PRODUCT/PROCESS CHANGE NOTICE (PCN)

PCN #: TB1311-02 DATE December 24, 2013 Product Affected: P9025-0AHGI8 shipped in Tape & Reel Date Effective: March 24, 2014	MEANS OF DISTINGUISHING CHANGED DEVICES: <input type="checkbox"/> Product Mark <input type="checkbox"/> Back Mark <input type="checkbox"/> Date Code Shipment starting from March 24, 2014. <input checked="" type="checkbox"/> Other
--	--

ATTACHMENT I - PCN #: TB1311-02

Figure1: Illustration of Existing & New Unit Loading Orientation in Carrier Tape

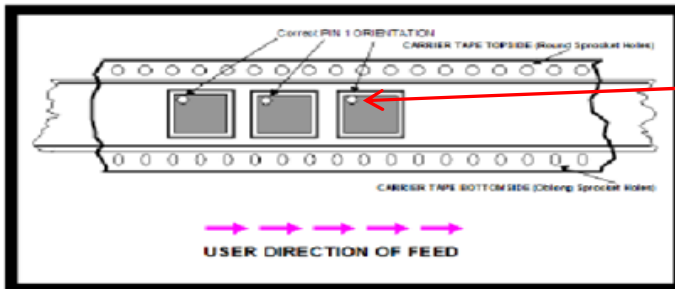
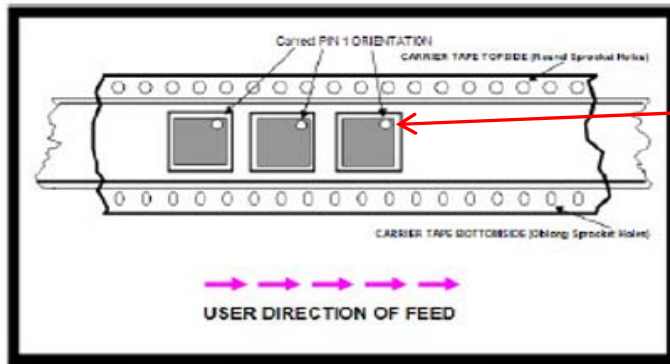
In addition, unit loading orientation in the carrier tape will be changed from Quadrant 1 to Quadrant 2.

Existing Orientation - Quadrant 1

Pin 1 at Quadrant 1

New Orientation - Quadrant 2

Pin 1 at Quadrant 2

Figure2: Illustration of Existing Carrier Tape Pocket and New Carrier Tape Pocket

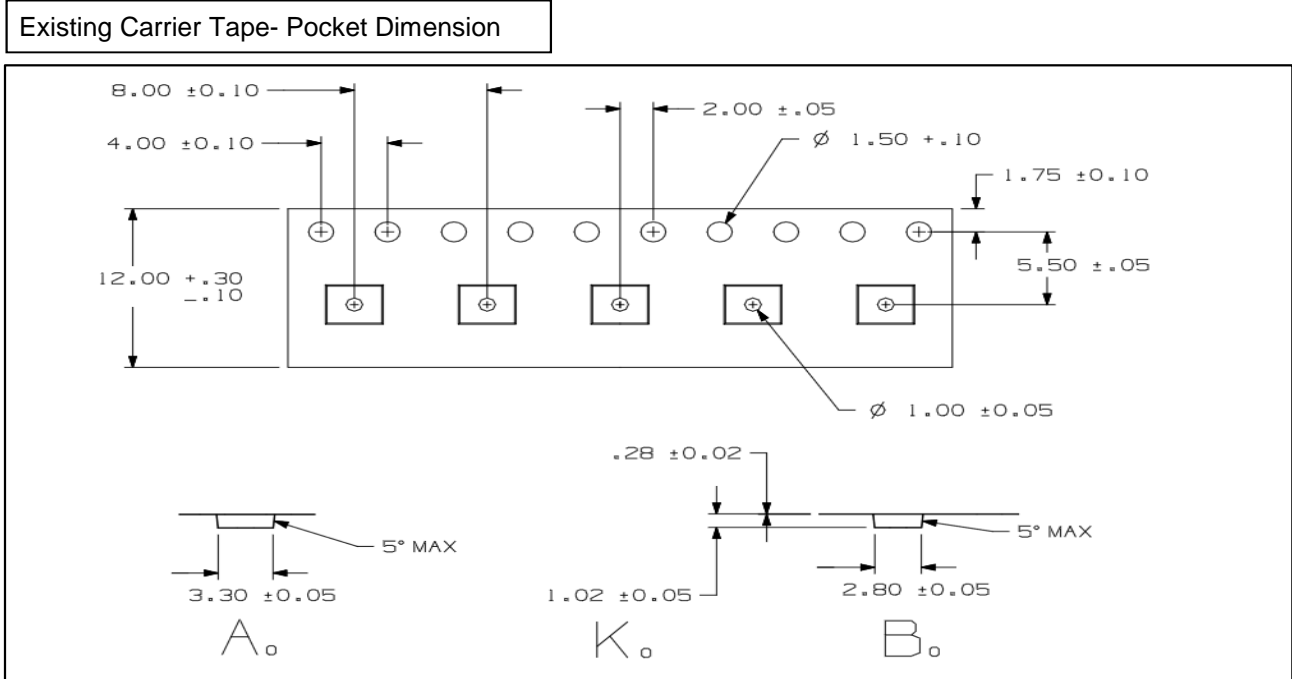
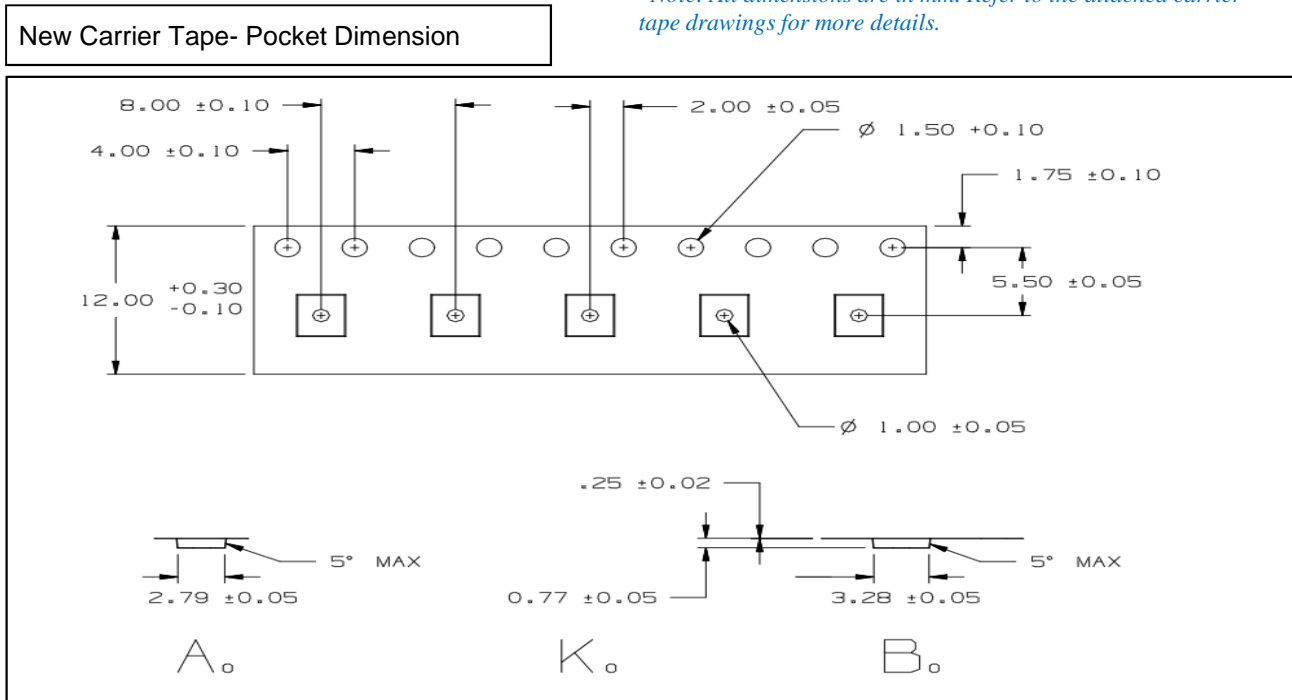
The new carrier tape has changes in pocket depth and design however the carrier tape pitch and width remain unchanged.

Refer to to Table 2, Figure 1, 2 and 3 for the comparison of the existing and new carrier tape in terms of carrier tape pocket dimensions, pocket designs and unit loading orientation respectively.

Figure3: Illustration of Existing Carrier Tape Pocket and New Carrier Tape Pocket

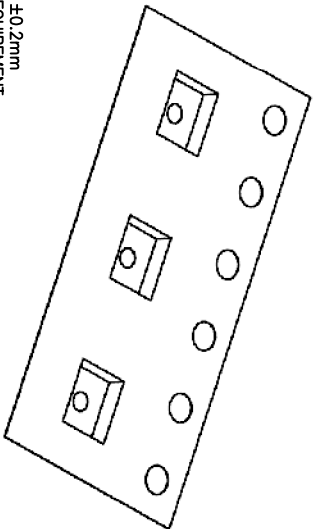
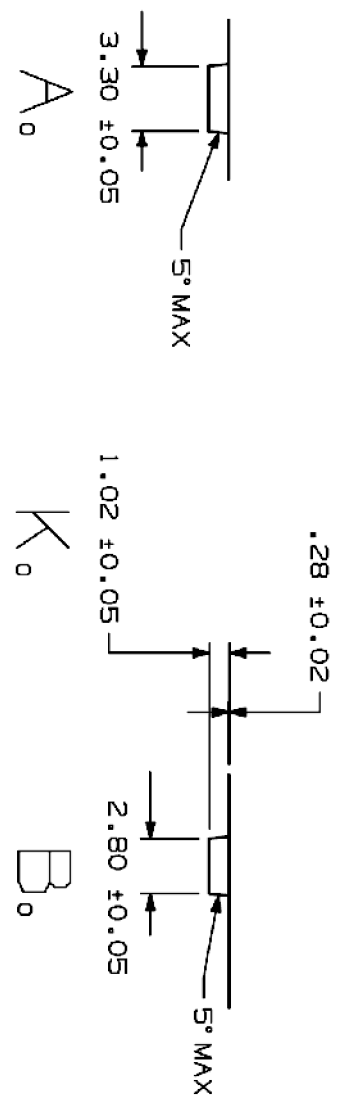
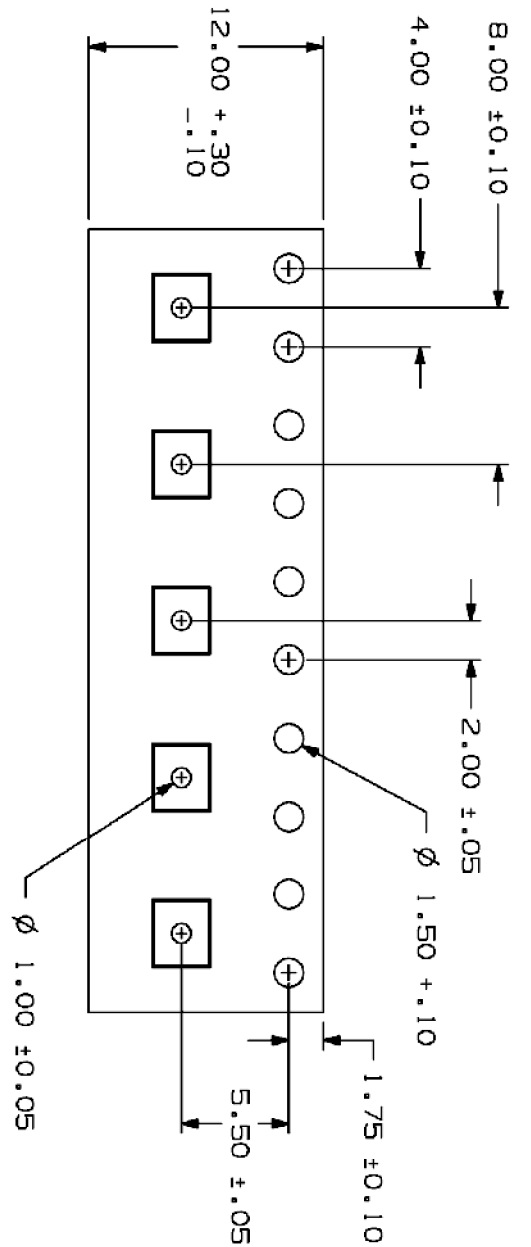
Existing Carrier Tape-
Pocket Design

New Carrier Tape-
Pocket Design
